Addendum No. 3

October 24, 2025

PROJECT: BUILDING DEMOLITION AND SITE CLEARANCE AT PARKVIEW TOWER

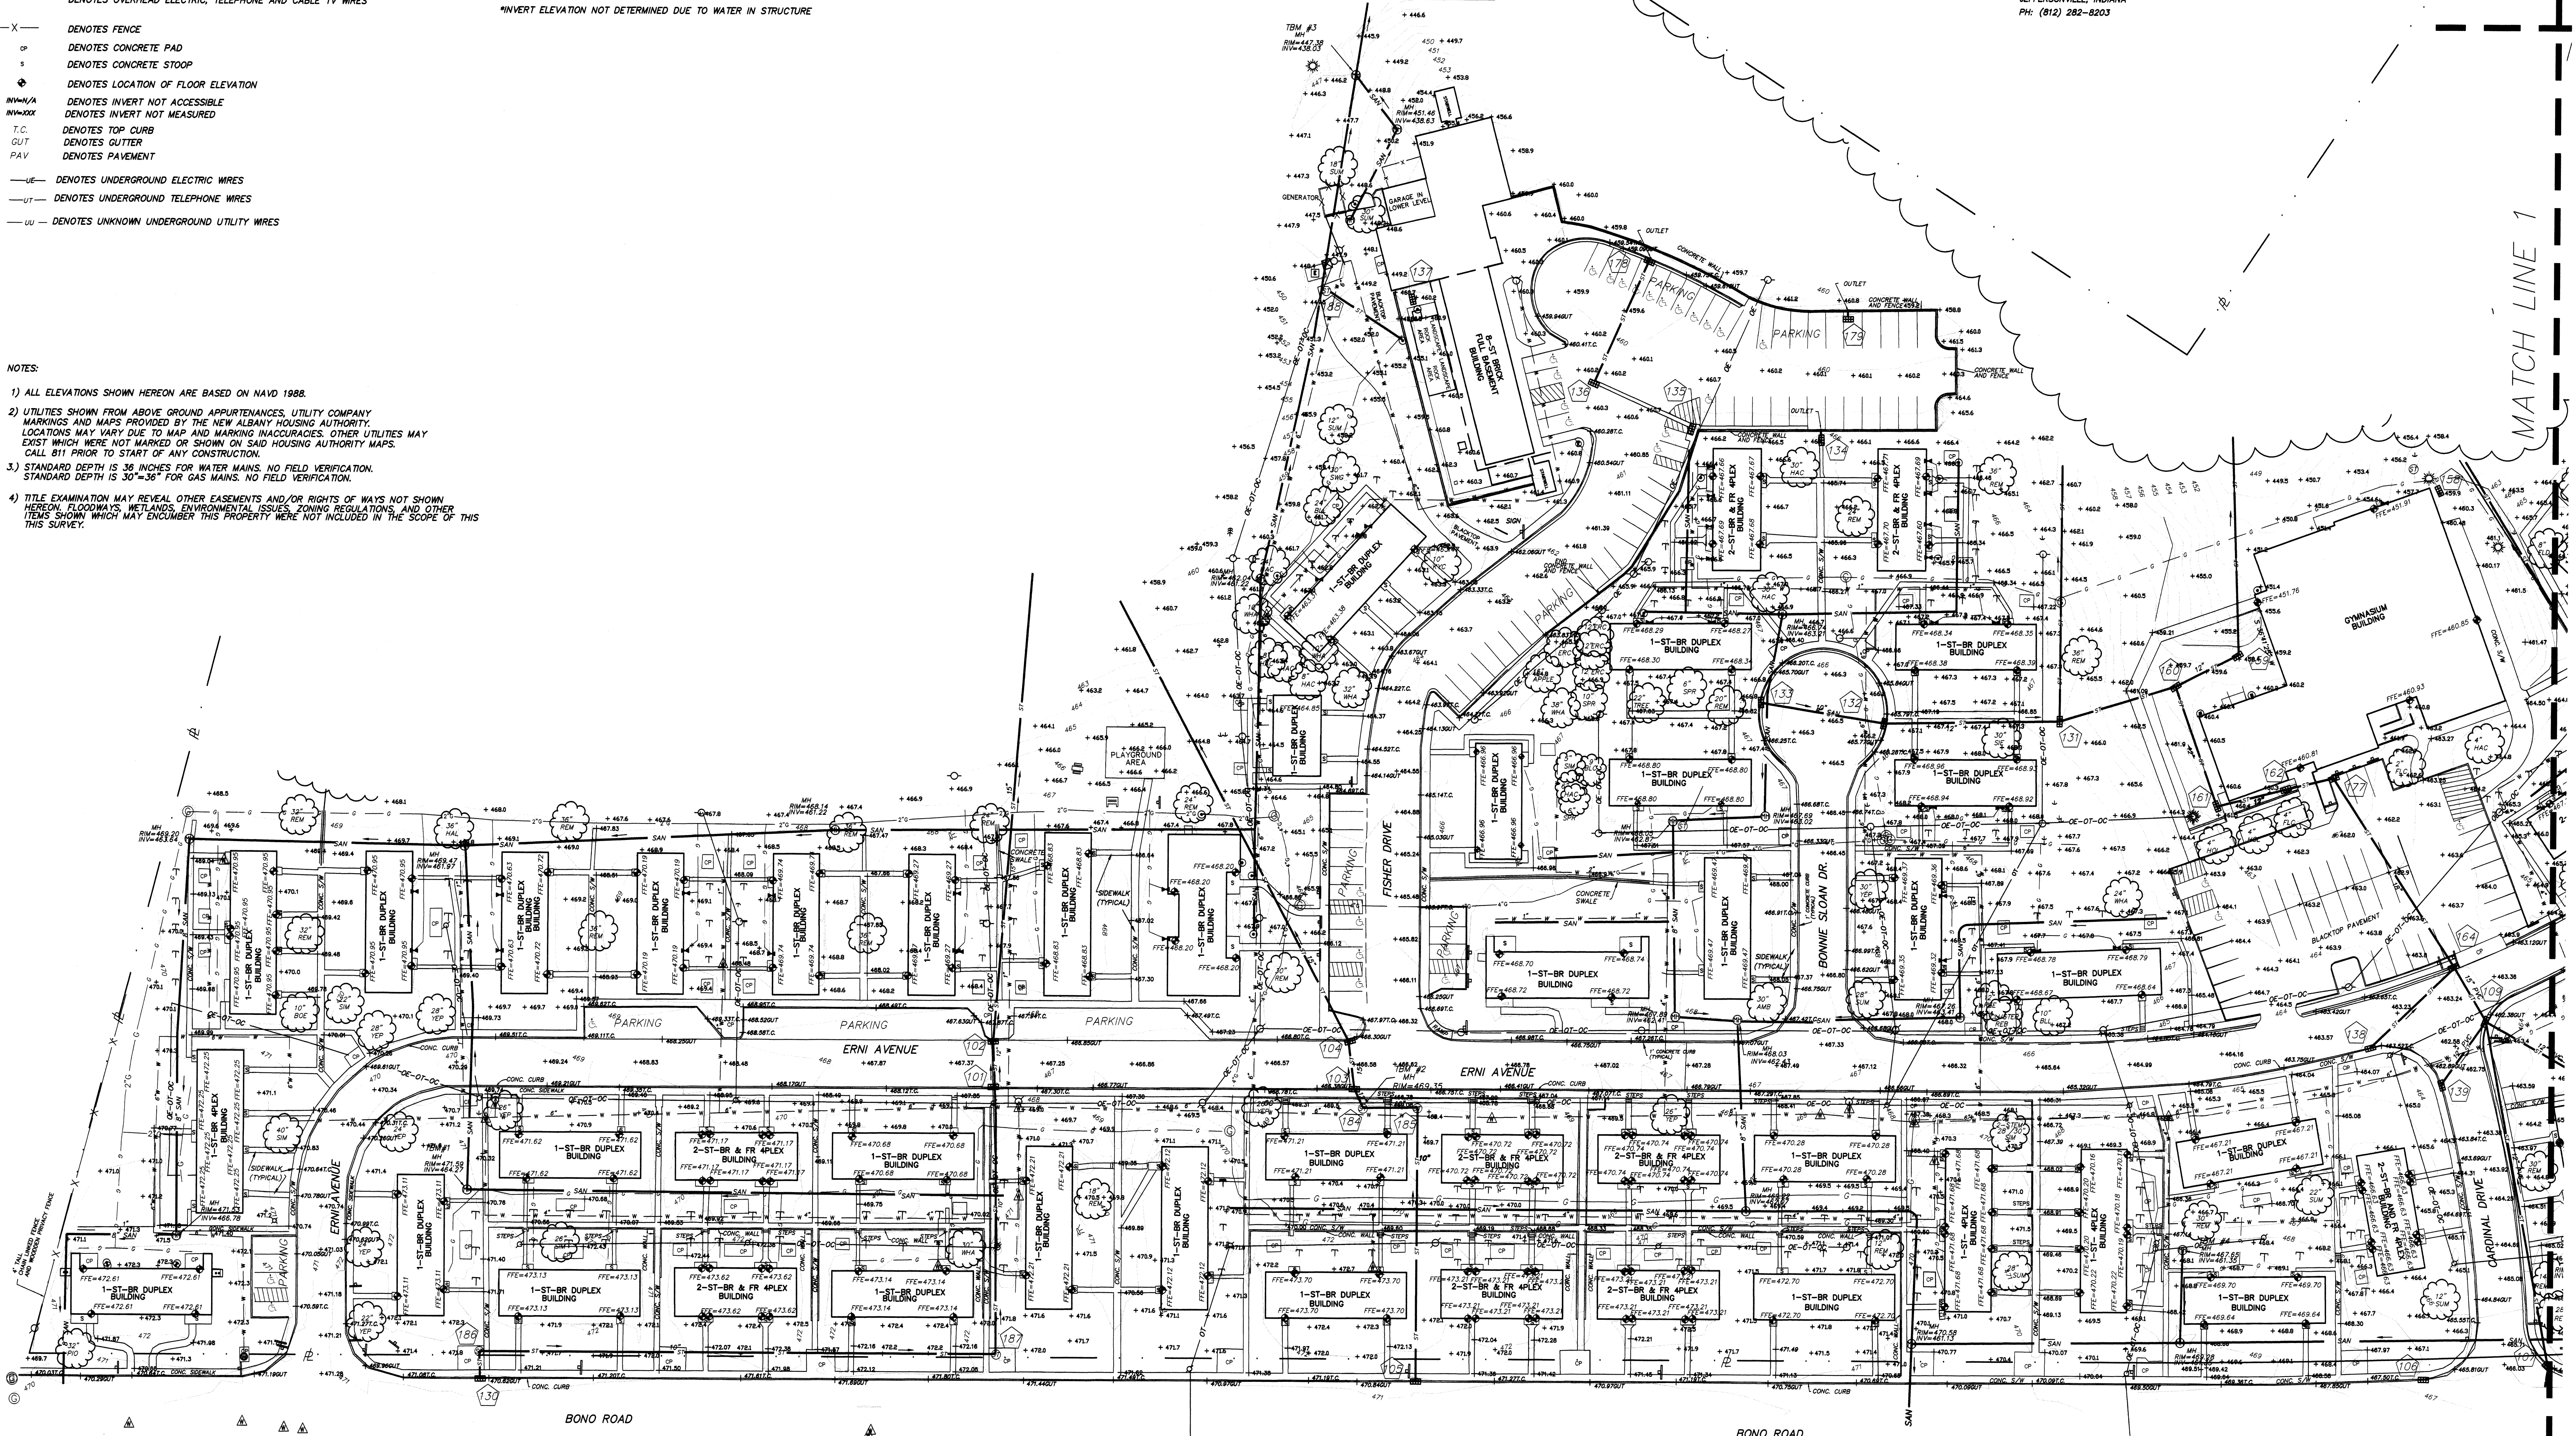
Item #16 – Attached to addendum #3 is an alternative ALTA Survey that is older than the survey provided with the RFP package.
